Project	IEEE 802.16 Broadband Wireless Access Working Group < http://ieee802.org/16 >	
Title	In-band Transparent Relay Frame Structure	
Date Submitted	2006-01-08	
Source(s)	<p>Kanchei (Ken) Loa, Yi-Hsueh Tsai, Chih-Chiang Hsieh, Yung-Ting Lee, Hua-Chiang Yin, Shiann-Tsong Sheu, Frank C.D. Tsai, Youn-Tai Lee, Heng- Iang Hsu Institute for Information Industry 8F., No. 218, Sec. 2, Dunhua S. Rd., Taipei City, Taiwan.</p> <p>Hang Zhang, Peiying Zhu, Mo-Han Fong, Wen Tong, David Steer, Gamini Senarath, Derek Yu, Mark Naden, G.Q. Wang</p> <p>Nortel 3500 Carling Avenue Ottawa, Ontario K2H 8E9</p> <p>[add co-authors here]</p>	<p>Voice: +886-2-2739-9616 loa@iii.org.tw</p> <p>Voice: +1 613 7631315 WenTong@nortel.com pyzhu@nortel.com</p>
Re:	IEEE 802.16j-06/034: "Call for Technical Proposals regarding IEEE Project P802.16j"	
Abstract	This contribution proposes in-band transparent relay frame structure	
Purpose	Text proposal for 802.16j Baseline Document

In-band Transparent Relay Frame Structure

Figure xxx(a) Example of minimum configuration for an in-band transparent relay frame structure

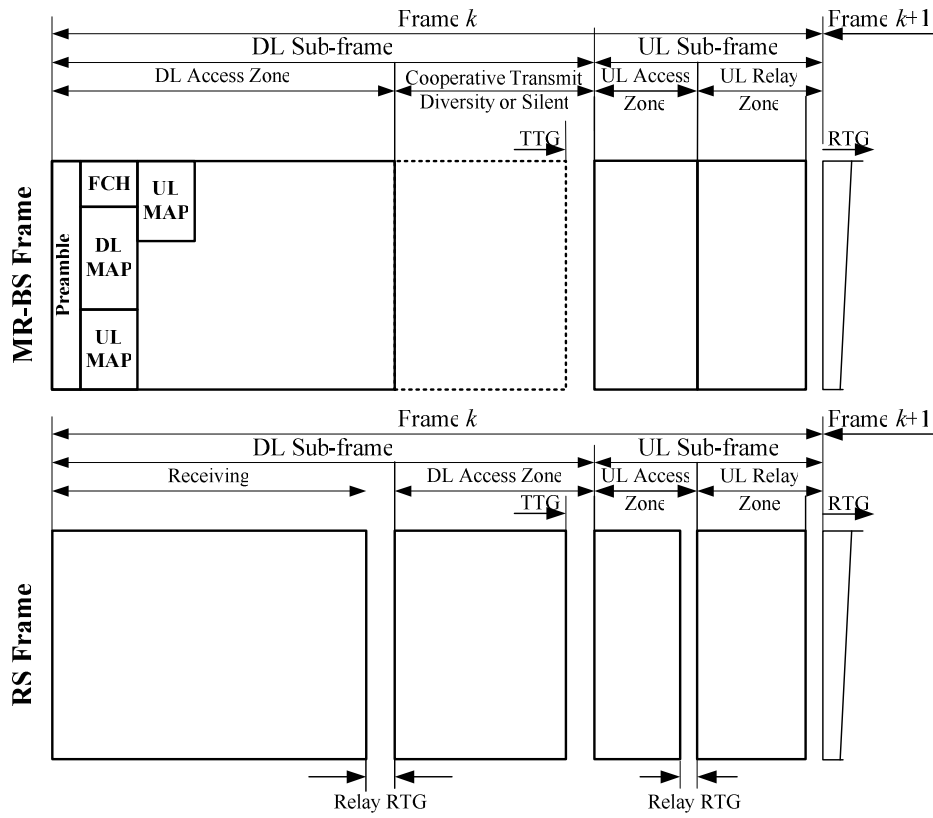
For the TDD mode, an example of the MR-BS frame structure is shown in Figure xxx.

Each MR-BS frame begins with a preamble followed by an FCH, a DL-MAP and possibly an UL-MAP. The DL sub-frame shall include at least one DL Access Zone and may follow by one zone used for Cooperative Transmit Diversity/Silent. The UL sub-frame may include one or more UL Access Zones and it may include one or more UL Relay Zones. In each frame, the TTG shall be inserted between the DL sub-frame and the UL sub-frame. The RTG shall be inserted at the end of each frame. In the DL Access Zone, the subchannel allocation, the FCH transmission, and the FCH shall be defined as in Section 8.4.4.2.

Figure xxx(b) Example of minimum configuration for an in-band upstream-only transparent relay frame structure

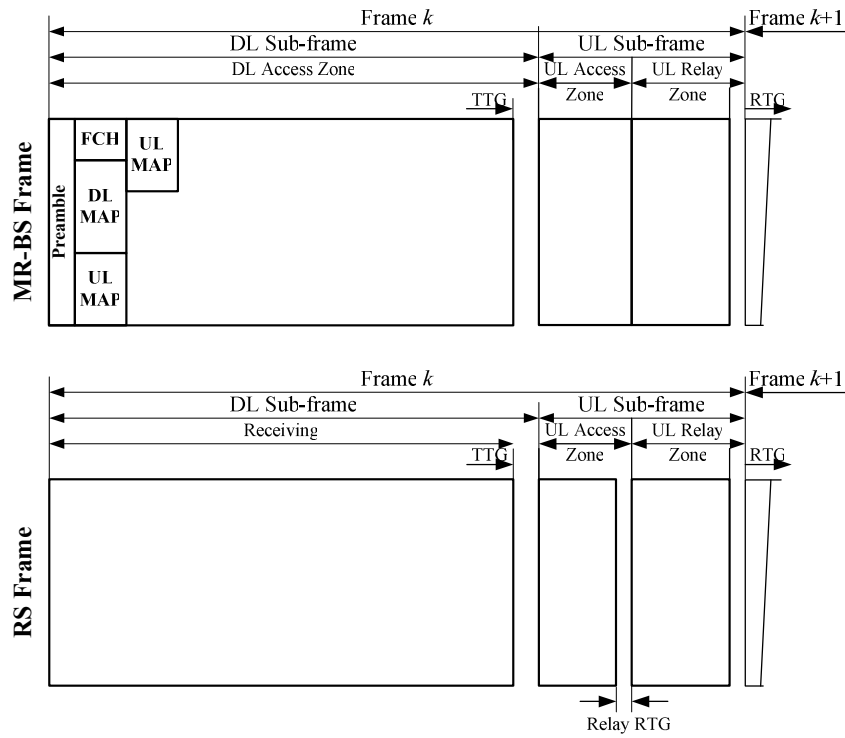
For the TDD mode, an example of an RS frame structure is shown in Figure xxx.

The Relay Station shall time aligned with its serving MR-BS frame start preamble. The DL sub-frame shall include at least one DL Access Zone and may follow by one zone used for cooperative Transmit Diversity/Silent.

The UL sub-frame may include one or more UL Access Zones and one or more UL Relay Zones. An R-RTG may be placed between a UL Access Zone and a UL Relay Zone.

If the relay station switches from transmission to reception mode, an R-TTG shall be required. If the relay station switches from reception to transmission mode, an R-RTG shall be required. There may be more than one R-TTG and more than one R-RTG inserted in the RS frame. In each frame, the TTG shall be inserted between the DL sub-frame and the UL sub-frame. The RTG shall be inserted at the end of each frame.
